Annex 5: HW change description v1.2 to Test Report 20-1-0017102T01a-C01-A5

SICK LOCU1xx – UWB TAG

v1r3 -> v1r3.1 change description

1. Battery holder: Pad adjustment of negative battery contact- milled grooves for battery holder are shifted in v1r3.1 comparing to v1r3. The pitch of grooves is increased by 0,45 mm.

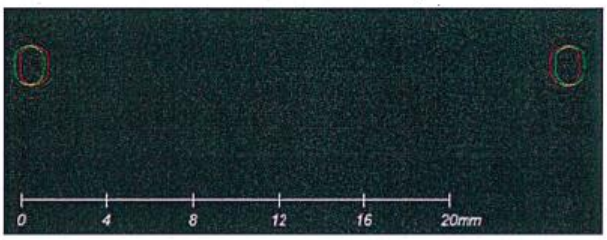
- red mark - v1r3
- green mark - v1r3.1
